**Mandatory
Service Bulletin**

**MAIN ROTOR BLADE ABRASION STRIP
DAILY INSPECTION REQUIREMENTS**

Figure 1 – 1.25 inch (31.8 mm) Chord Abrasion Strip

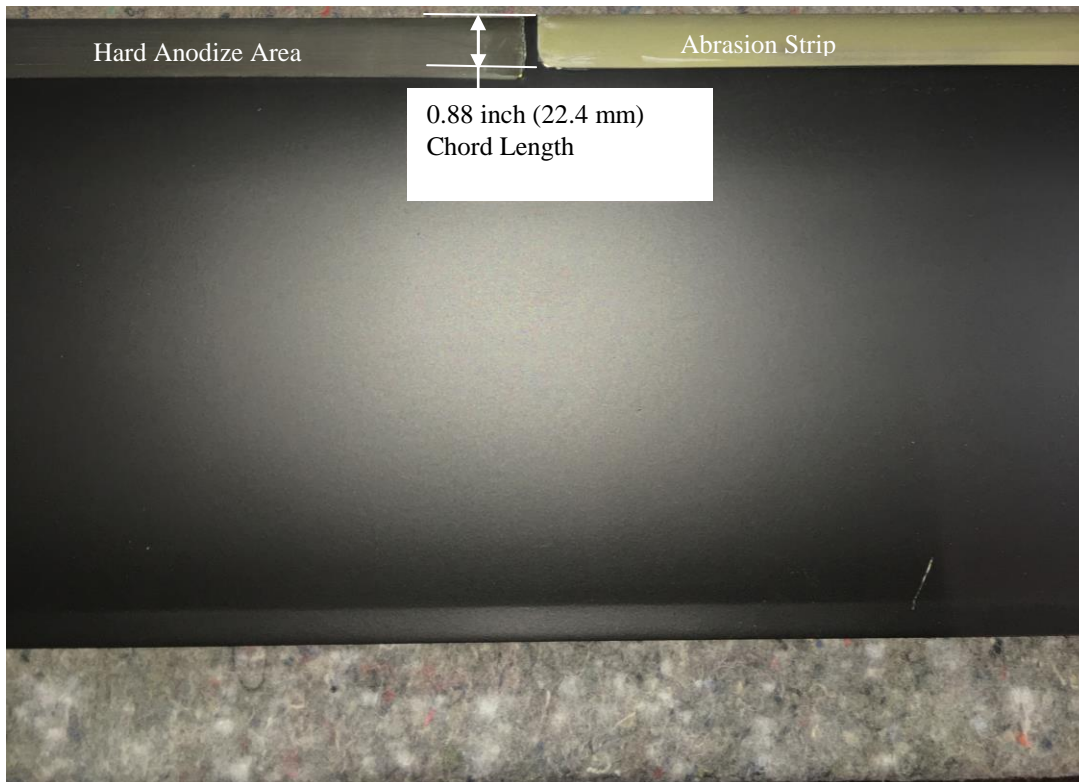
Subject
to this
Mandatory
Service
Bulletin

Subject
to this
Mandatory
Service
Bulletin

Not
Subject
to this
Mandatory
Service
Bulletin

Not
Subject
to this
Mandatory
Service
Bulletin

- 1) Determine which Chord Length Abrasion Strip is present on the subject blade and Total Time Since New (TTSN) or since Abrasion Strip Replacement to determine if this Mandatory Service Bulletin is applicable. Reference **Figure 1** and **Figure 2** on Page 2.

- 1) If applicable, Fielded Main Rotor Blades are to be returned to the HTC Factory or an HTC Authorized Repair Station qualified to perform this modification. This modification consists of the removal and replacement of the Abrasion Strip with a 0.88 inch (22.4 mm) chord Stainless Steel Abrasion Strip in accordance with HTCQ-004, Revision I (or later approved revision) Standard Repair Instruction – Main Rotor Blade. Installation of the 0.88 inch (22.4 mm) chord Stainless Steel Abrasion Strip shall constitute compliance and repeating **PART 1** is no longer required.

Figure 3 – Inboard Abrasion Strip Area

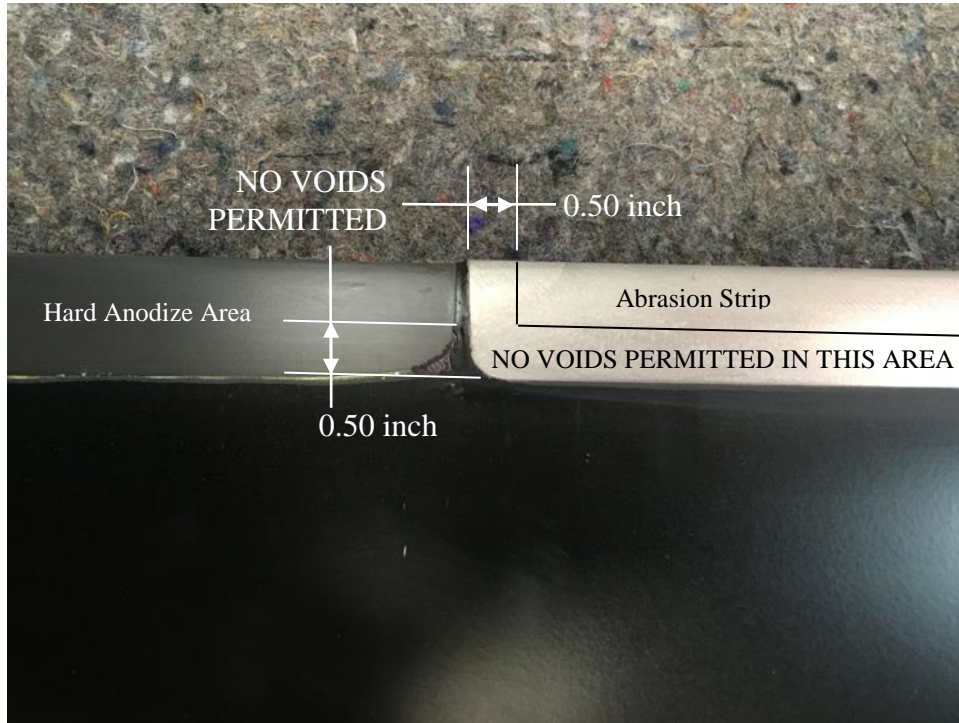
- 5) If any Void is found within 0.50 inches (12.7 mm) of any edge regardless of size, replace the subject blade with another airworthy blade, Reference **Figure 3** and **Figure 4** on Page 5. **Note: Do not attempt a field repair.**
